SUBJECT: Forwards changes to FSAR App 15E, "Complete Core Offload/
 Reload Procedure Guidelines," in response to D Florek
 comments. Changes will be included in subsequent amend.

Re: Nine Mile Point Unit 2
Docket No. 50-410

Enclosed are changes to Appendix 15E of the Final Safety Analysis Report, "Complete Core Offload/Reload Procedure Guidelines." These changes will be included in a subsequent amendment.

Figure 15E.3-3 - Initial Core Fuel Loading Sequence

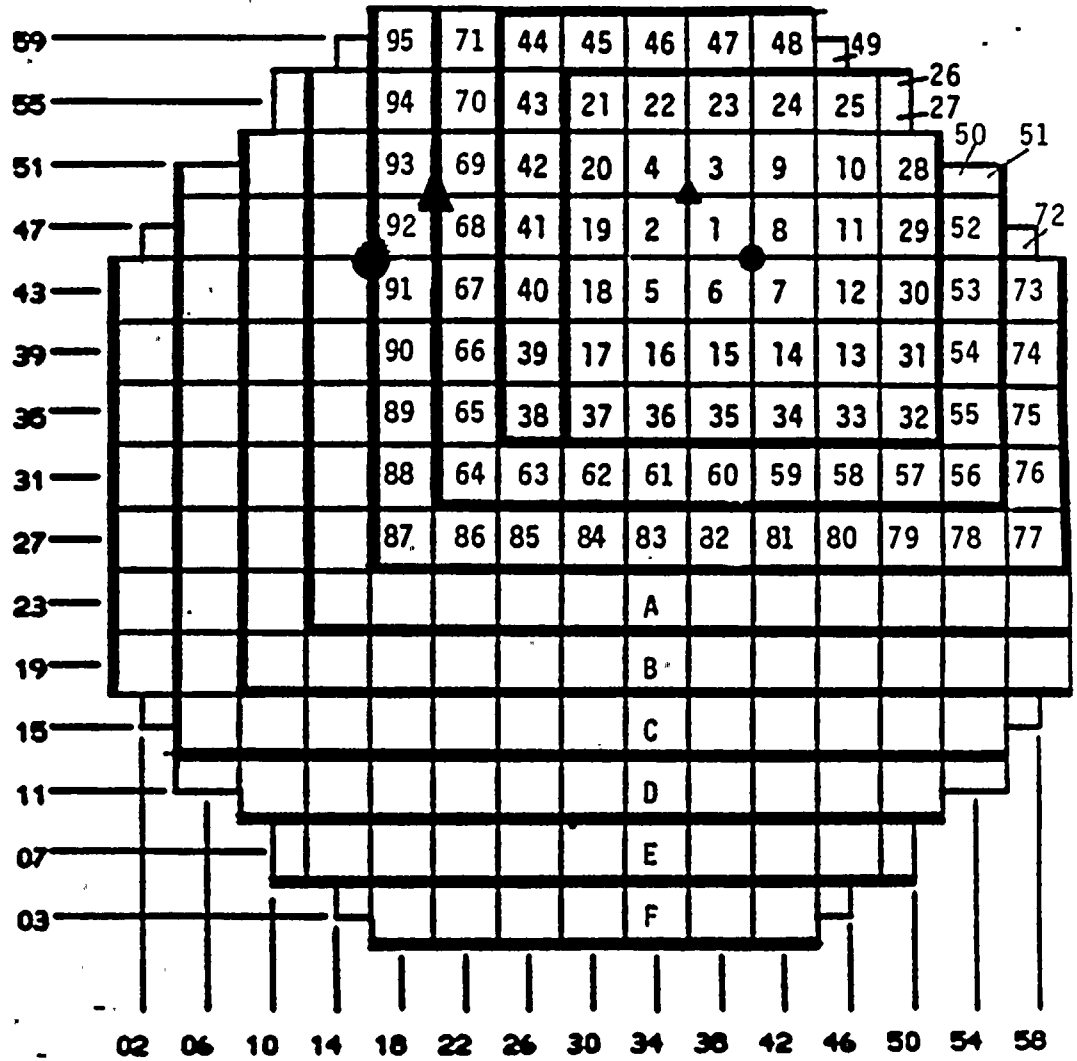
The changes on pages 15E.3-15, 15E.3-11 and 15E.6-1/6-2 are provided in response to a comment made by Don Florek of Region I. Mr. Florek wanted two source range monitors on scale when performing the shutdown margin test. Niagara Mohawk proposes loading an additional two rings of fuel in order to satisfy Mr. Florek's request. These proposed changes were discussed with Mary Haughey and Carl Schulten of your staff.

When 362 fuel assemblies have been loaded (Step 95 in Figure 15E.3-3), an SRM will be surrounded by fuel and indicating greater than 0.7 cps. At this time, a partial core shutdown margin test will be performed as required by Regulatory Guide 1.68. Core physics calculations for the off-center partial SDM test have been performed for the proposed fuel loading sequence (Reference 8). After the partial core SDM test, the

After the initial 16 assemblies are loaded and an SRM is on scale, the fuel loading will continue in a spiral fashion as shown in Figure 15E.3-3. Since only one SRM will initially be on scale, a portable source will be used to periodically demonstrate operability of the SRM's located in areas with no fuel. One of the SRM's will be required to maintain continuous visual indication in the control room until other SRM's are on scale. Use of a portable source to demonstrate operability of the remaining SRM's has previously been approved by the NRC for other plants (References 1 and 7). The portable source is widely used in the nuclear industry as a bugging source for detector calibration and is an easy device to operate with no complex or unsafe maneuvers required.
